MEMORANDUM

REVIEW TYPE: Site Plan Review
APPLYING FOR: Bank with drive-in
PROJECT NAME: Wisteria Business Park
CASE #: 8-03018
REVIEW BASIS: Site Plan Review Required in the O-M Zone, Section 59-C-341.2
ZONE: O-M Commercial
LOCATION: Germantown
Southwest intersection of Route 118 and Wisteria Drive
MASTER PLAN: Germantown
APPLICANT: Mid-Atlantic Federal Credit Union
FILING DATE: December 9, 2002
HEARING DATE: May 15, 2003

LANDSCAPE & SITE LIGHTING PLAN
WISTERIA BUSINESS PARK
SOS 2.2.3
CLANSBURG ELECTION DISTRICT No. 2
MONTGOMERY COUNTY, MARYLAND

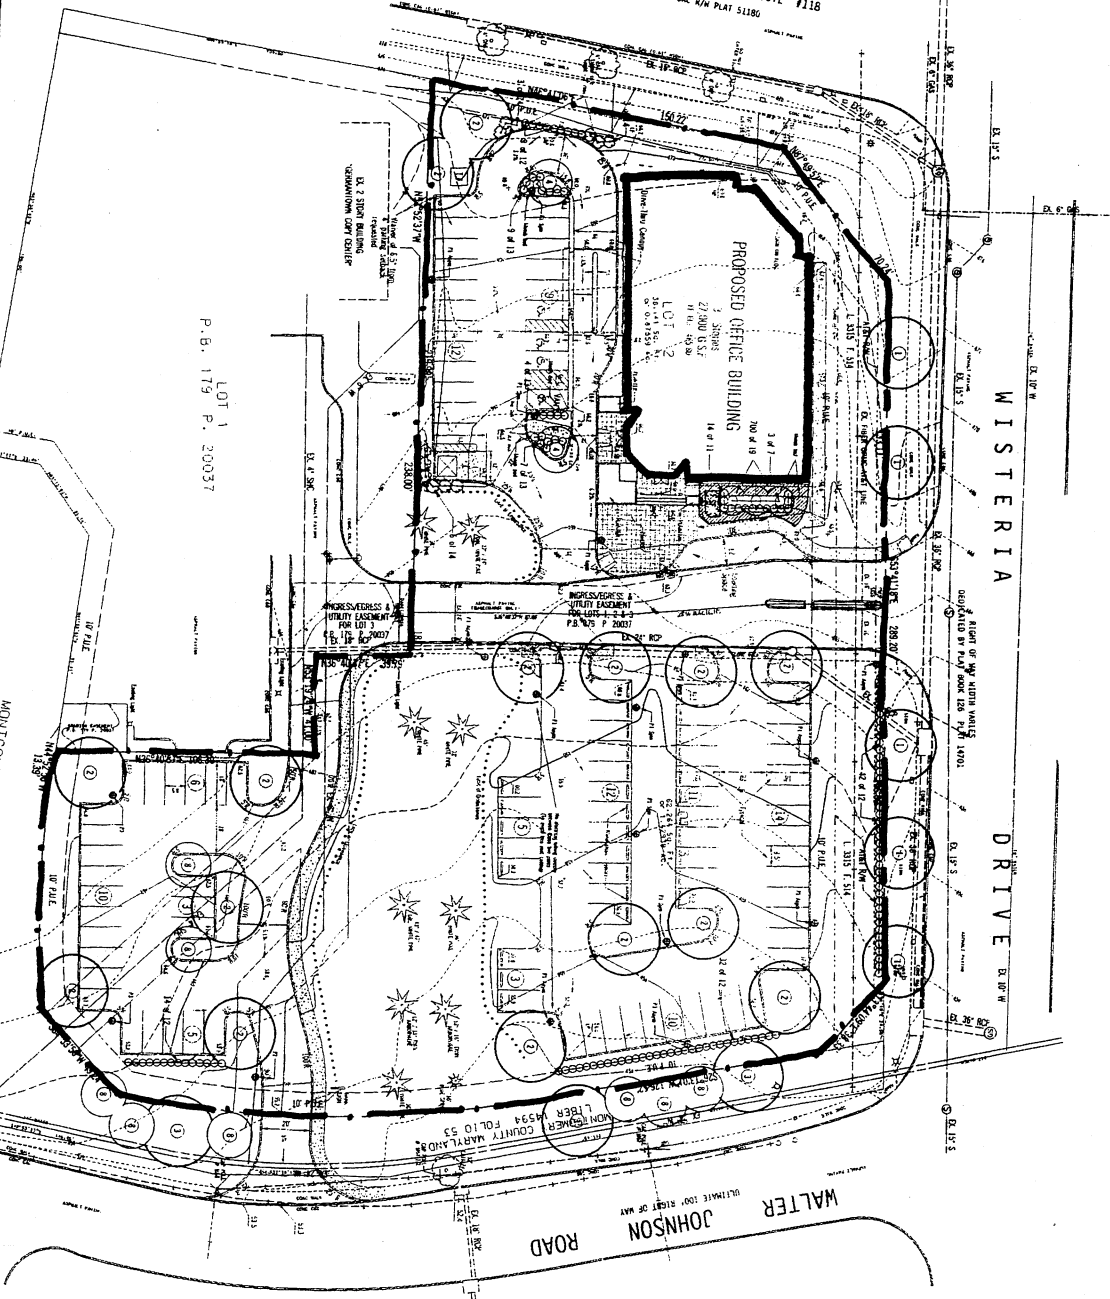
- d. Label and identify the correct number of parking spaces required and provided on the site.
- e. Landscape and Lighting Plan to show the following:
 - i. Provide a lighting distribution plan showing details and specifications for lighting fixtures (fixtures, cut sheets, wattage, illumination summary, pole height, deflector shields); lighting levels shall follow the Illuminating Engineering Society of North America (IESNA), Lighting for Parking Facilities, RP-20-98, which recommends that light levels in parking lots where enhanced security is desired, not exceed a 15:1 Maximum to Minimum Uniformity Ratio;

- ii. Distribution Plan to include any wall pack or wall mounted fixtures on the proposed building;
 - iii. Distribution Plan to include safety lighting methods to address after-hour lighting distribution;

- iv. Light poles not to exceed 18 feet in height;
 - v. All light fixtures shall be full cut-off fixtures;
 - vi. Deflectors to be installed on all fixtures causing potential glare or excess illumination;

Exterior lighting is proposed for the building and the ancillary parking area. Lighting was reviewed for safety and conformance to parking standards for commercial properties and parking facilities. Pole heights will be limited to 18 feet. Deflector shields will also be required to mitigate any negative glare or illumination on the public roads.
